24/6/04
Luan & Hunters No 735

760 x 87.5 x 60.5 mld.

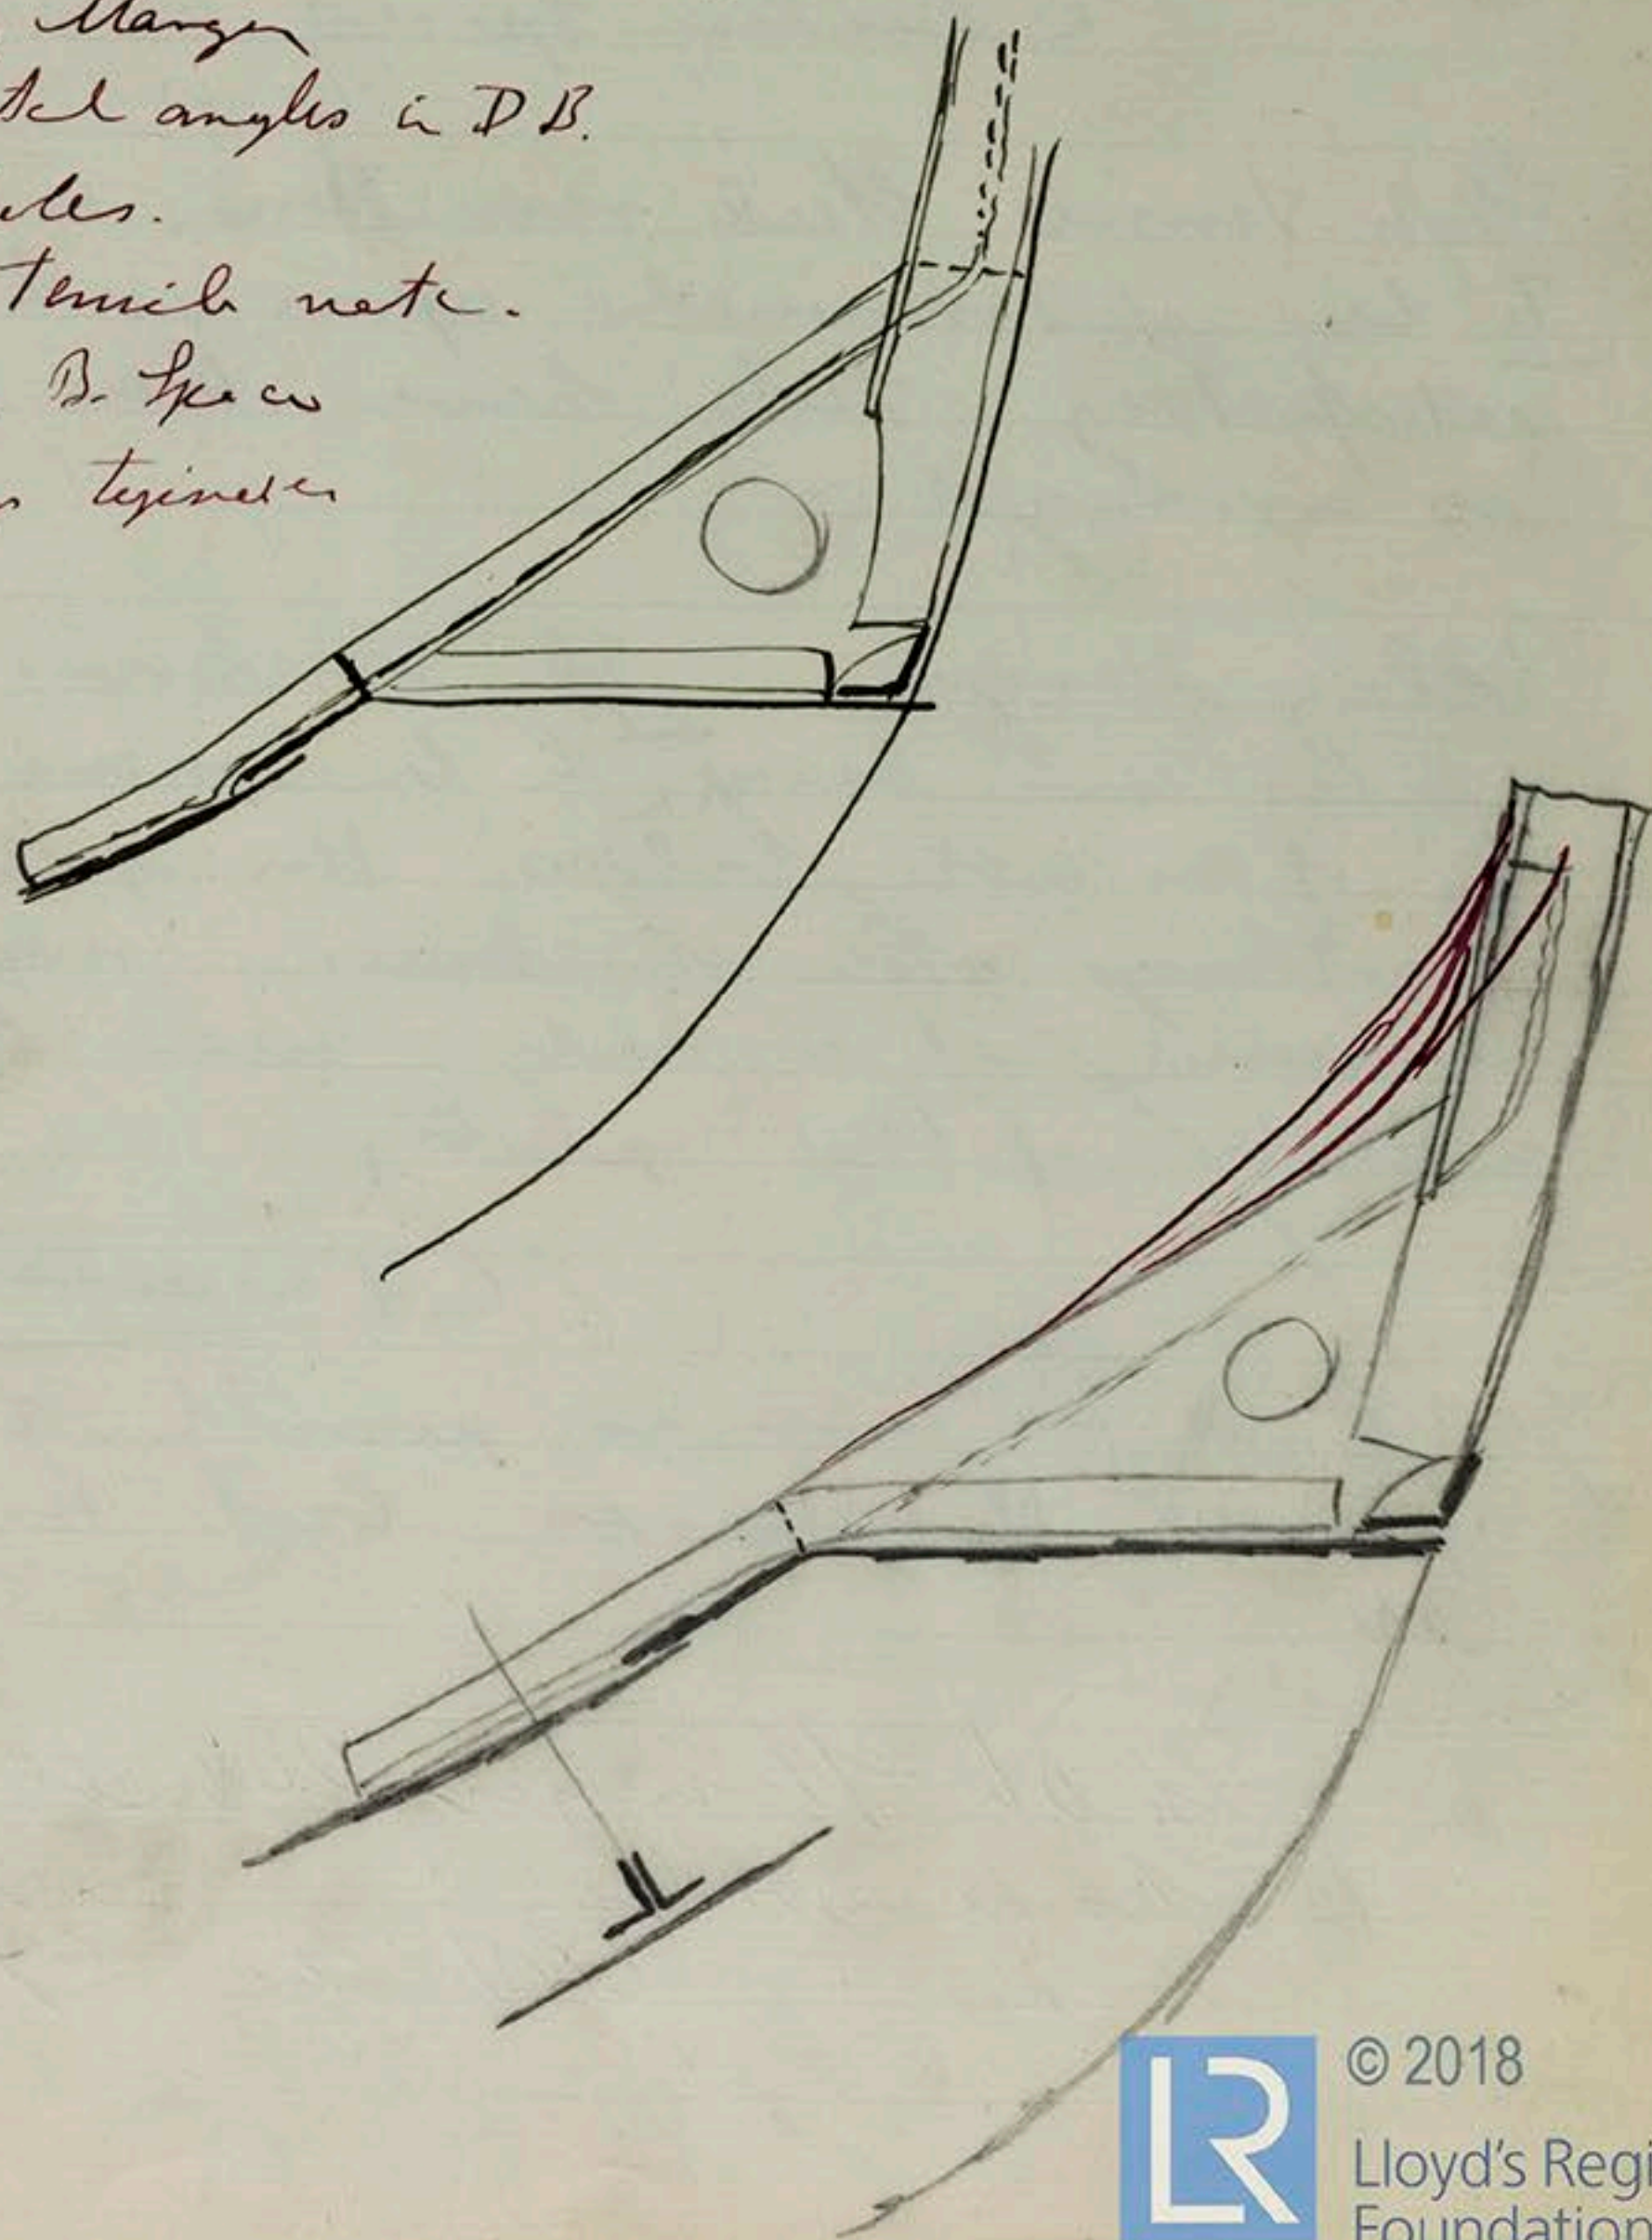
- Spacing of rivets in frames below L Sh.
- Ribbed rivetted Landings sh L & Width
- Attachment of cent. G. in D.B.
- Rolling Margin
- Beams where short span on
- L Sh. Indicate how Wd $\frac{10}{16}$ ft.
- Landing of top side strokes

Rolling Margin

Intersected angles in D.B.

Manholes.

High Tensile note.

Rev. in D. Space

Landing top side

Fan angle on web stringers $6\frac{1}{2} \times 4\frac{1}{2} \times 10\frac{1}{2}$
to dia. p.l. $45 \times 12 \times 1\frac{1}{2}$.

Intermittent attachment double
each side of bulkheads.

Beams less when span less.

Floors at Boiler Hoods $12/20$
in Boiler Spaces at Boiler Hoods
 $10\frac{1}{2}$ elsewhere

High tensile steel reductions in scantlings
to be determined upon when
satisfactory tests have been made
as arranged.

Rolling Margin. The thickness of
plates and bars ^{not} to be more than
 $\frac{1}{40}$ of an inch below the specified
scantlings. The thickness may be
measured at a hole near the
middle of the plate.

if necessary

to be as near as possible to the
approved thicknesses but in no
case

th. of stringer double $\frac{21}{20}$
th. of girders " $\frac{21}{20}$
th. of " U.S. th. $\frac{20}{20}$

Plans amended in accordance
with original spec. Sec.
